Amended Map

Corrected sketch to file with Application #2673 Permit #1465, recorded book 6 page 1465 of water rights of the State of Oregon

I, H. W. Herring of McMinnville, Oregon, do hereby certify that this correction map was made from notes taken during a survey made by myself on Dec. 17th 1915 and that it represents the works as now constructed under permit #1465, application #2673.

Sketch showing position of Springs or seepage from the Collecting basin
Scale 1 inch = 10 feet.

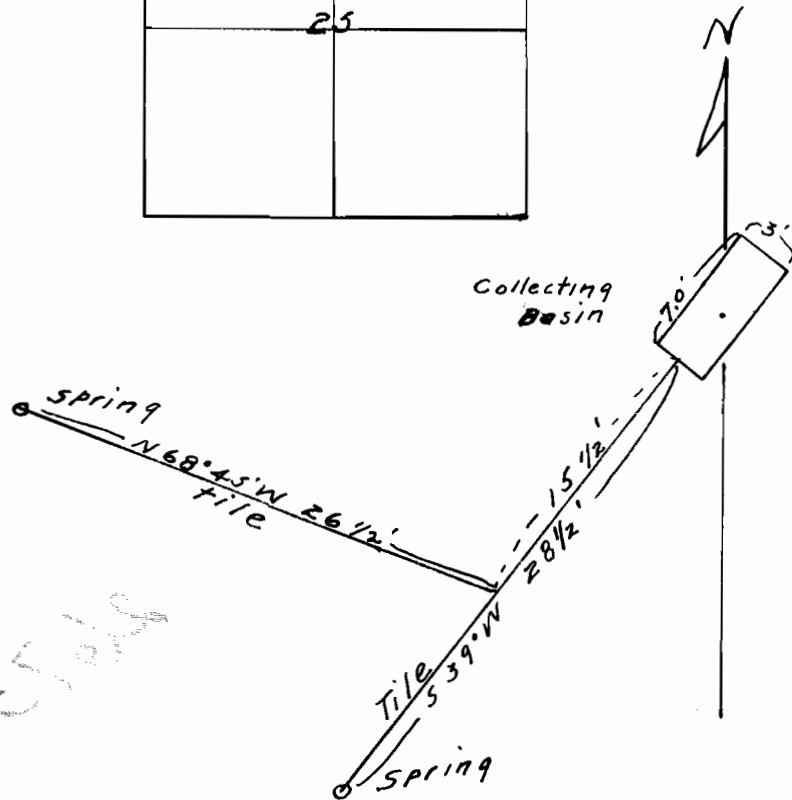
The water from the same spring and seepage being used and same amount appropriated. The change in location of collecting basin being farther up the branch at head of draw, change made to get basin near spring to avoid filth and muddy water from open branch.

The center of new basin is 258.54 ft South and 88.45 ft West of the 1/4 post between Sections 24 and 25 in Tp. 5. S. R. 4. W. of the Will. Mer.

The dam across this same branch which was first used and as permitted in permit #1465 was 494.5 ft South and 267. ft East of the above described 1/4 corner.
